MEMORANDUM
REVISION TO EXISTING APPROVED VOLUNTARY CORRECTIVE
MEASURES WORK PLAN FOR
SOIL REMEDIATION AT SITE SS-61 (August 2006)
HOLLOMAN AFB, NEW MEXICO

DATE: April 24, 2009

FROM: Frank Gardner and Chuck Schick, Bhate Associates, Inc.

SUBJECT: REVISION TO EXISTING APPROVED VOLUNTARY
CORRECTIVE MEASURES WORK PLAN FOR
SOIL REMEDIATION AT SITE SS-61
HOLLOMAN AFB, NEW MEXICO
(HWB-HAFB-05-007 and HAFB 05-008)

Table 4-1
Excavation Sampling Quantities and Analysis

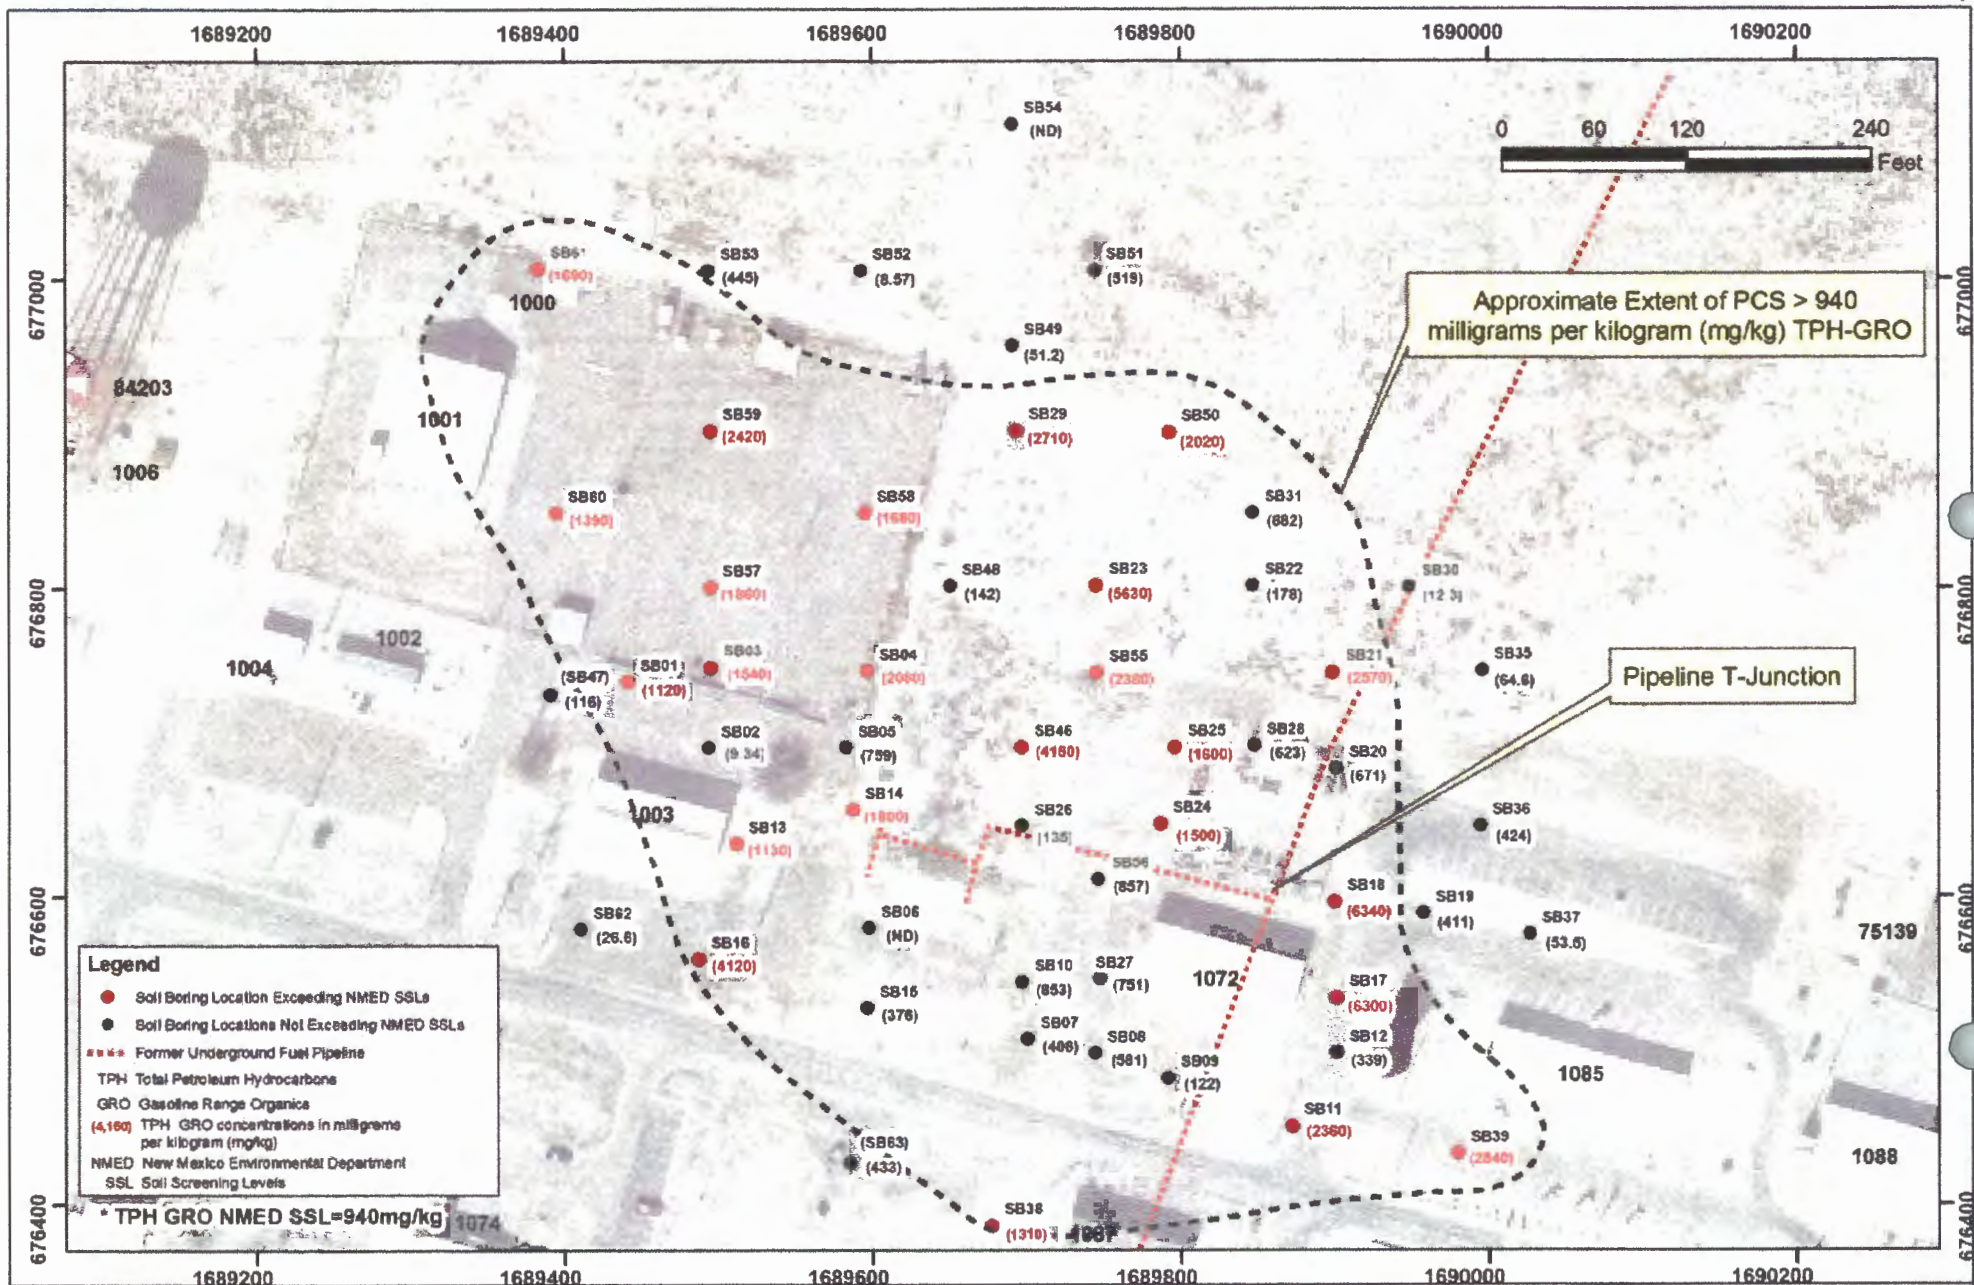
1. The currently approved plan requires the screening un-impacted overburden every 25 yards using an organic vapor analyzer (OVA) or photoionization detector (PID). The modification requests increasing this interval to every 500 yards. Based upon the estimated volume, up to 182 samples could be analyzed for hydrocarbons using a PID or OVA.

2. The currently approved plan requires confirmation field screening (using ultraviolet fluorescence) is required every 50 yards. The modification requests increasing this interval to every 2000 yards. Based upon the estimated volume, up to 46 samples could be analyzed for hydrocarbons using the SiteLab® technique and equipment.

3. Once stockpiled, the un-impacted overburden will be sampled every 3500 cubic yards instead of the current interval of 200 yards. Based upon the estimated volume, up to 26 samples could be submitted for laboratory analysis.

4. Excavation confirmation sidewall sampling will be done every 50 lineal feet of sidewall instead of every 18 feet. Based upon the size of the anticipated excavation up to 51 soil samples will be collected for confirmation laboratory analysis.

A direct comparison of these changes are illustrated in the modified version of **Table 4-1** (Excavation Sampling Quantities and Analysis) from the Approved work plan. The changes are illustrated with a strikethrough of the current quantities and the new quantities are underlined.

Sample Type	Contamination Profile	Purpose	Frequency	Estimated Quantity	Method/Analyses	Requested Analyses Time
Overburden	Un-impacted Soils	Initial Field Screening	Every 500 cu yds	20 <u>182</u>	OVA / VOCs	Real Time
		Field Confirmatory	Every 2000 cu yds	40 <u>46</u>	UVF / TPH	
Stock Pile (Overburden)	Un-impacted Soils	Backfill Characterization (Lab validation)	Every 3500 cu yds	3 <u>26</u>	Laboratory/TPH, VOCs, and SVOCs	24 hours
Excavation Confirmation	Clean wall denoting extent of excavation	Closure	2 every 50 In ft, at mid-depth within contamination zone, minimum of 1 per side wall if < 18 In ft	44 <u>51</u>	Laboratory/TPH, VOCs, and SVOCs	7 days

Areal Extent of the PCS Horizon
 Pipeline T-Junction Source Area

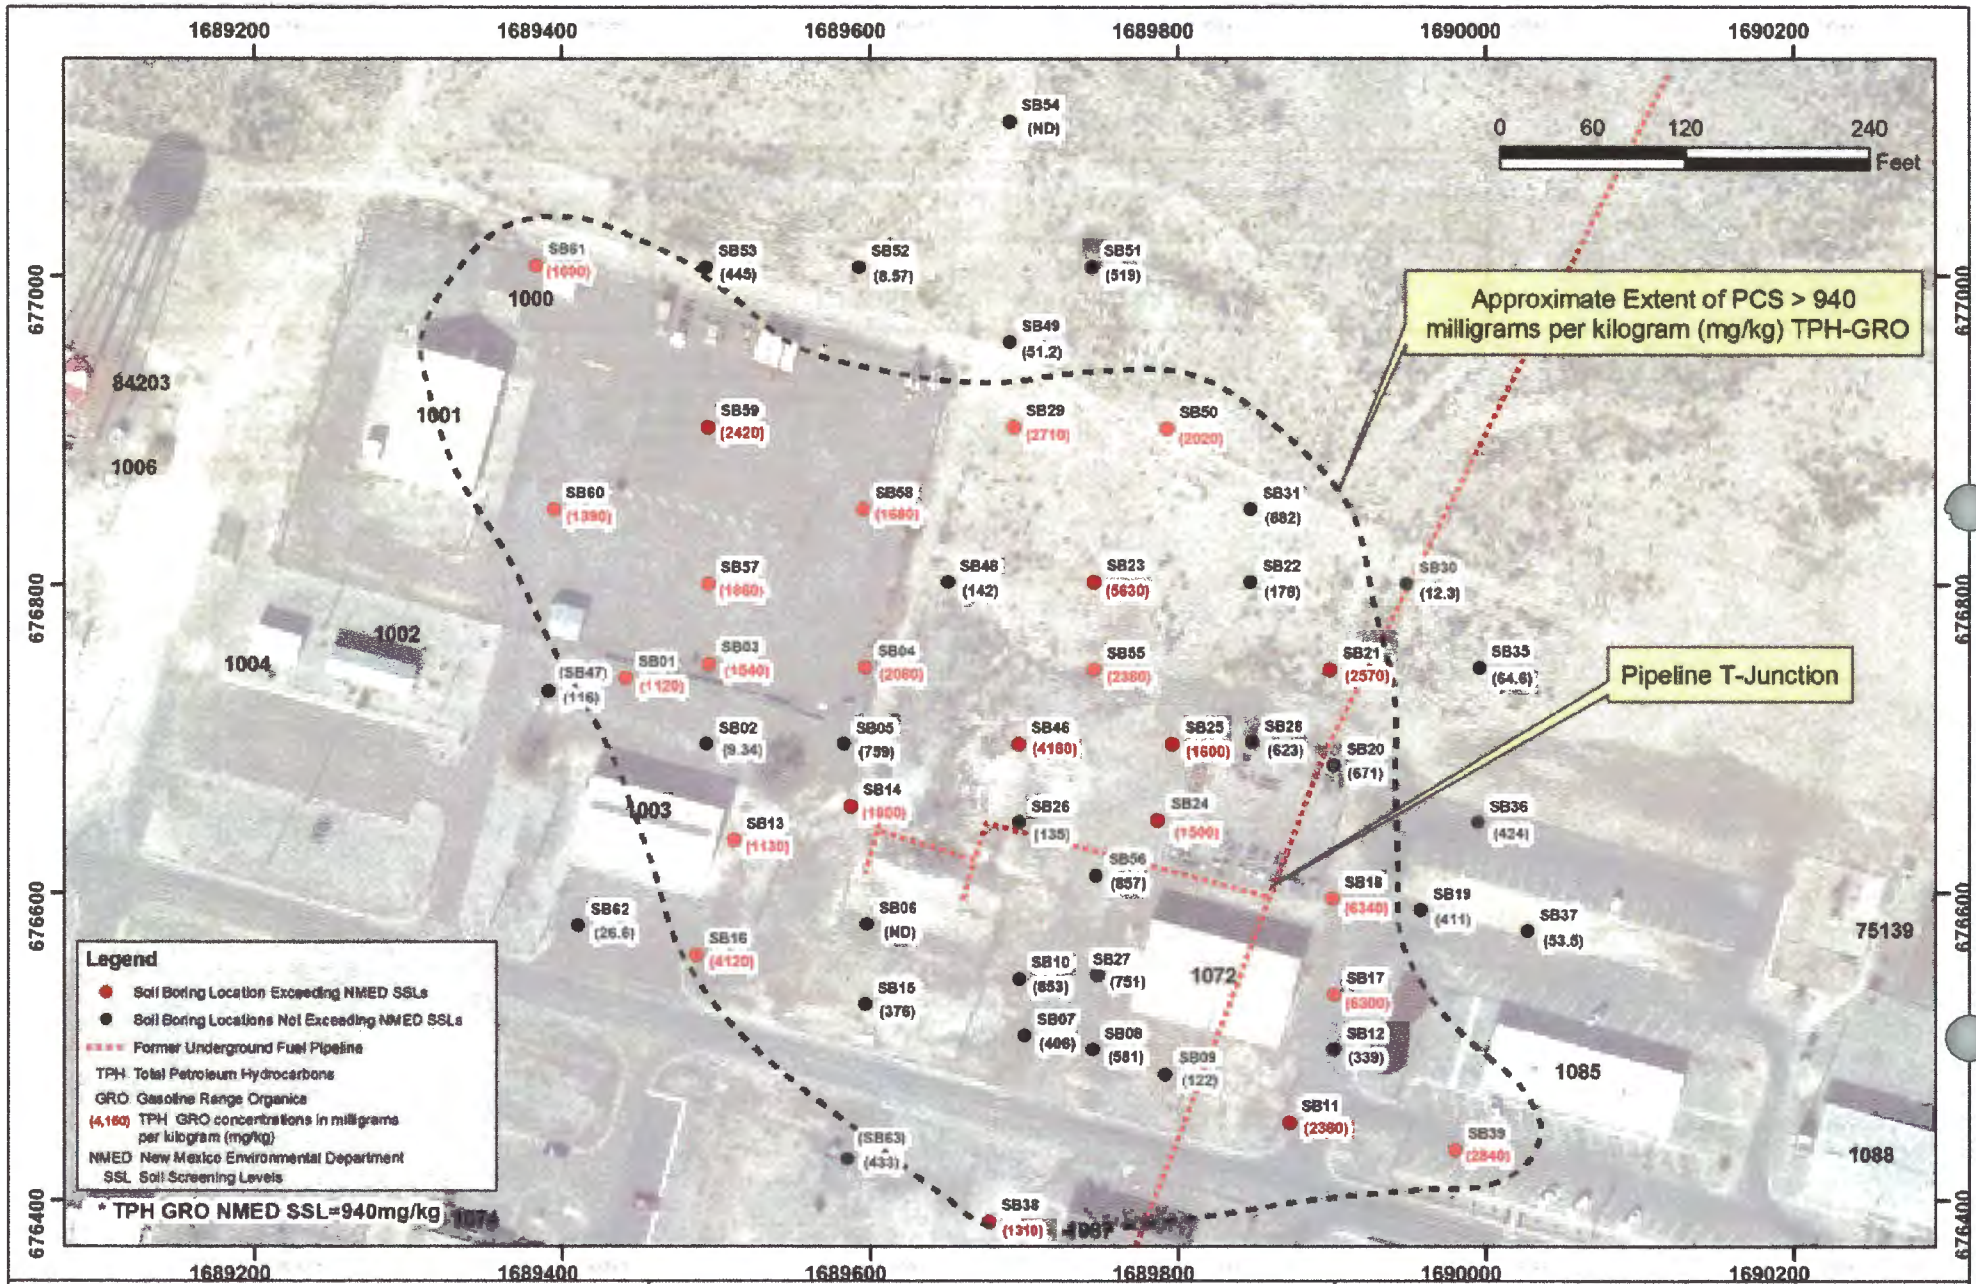
Attachment 6 is a map of the area to be remediated through excavation and land farm treatment. The estimated volume of clean overburden is 90,680 cubic yards. The estimated volume of PCS to be removed and treated is 120,906 cubic yards. Using attachment 4, the calculated lineal feet of side wall for the excavation is approximately 2550 lineal feet.
